Consolidated Response to the

2011 Reactor Oversight Process External Survey

October 18, 2012

Fig 10.4: Proposed ROP Flowchart

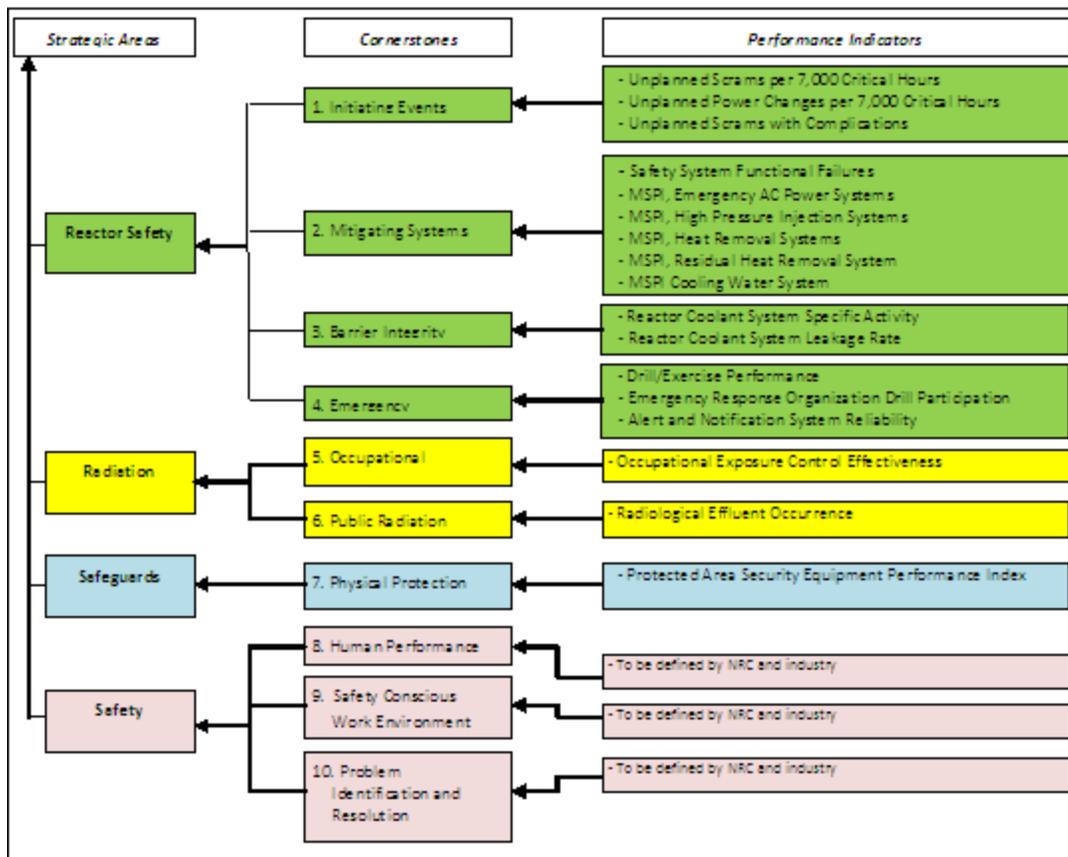
- Sometimes, depending on the relationship that exists between the NRC and the licensee/NEI, and on political pressures.
- It is difficult to answer this question given the way it is asked. What do you mean by "help?" Safety culture should be fully incorporated into the ROP by making it a 4th Strategic Area. We think the ROP ought to look like this:
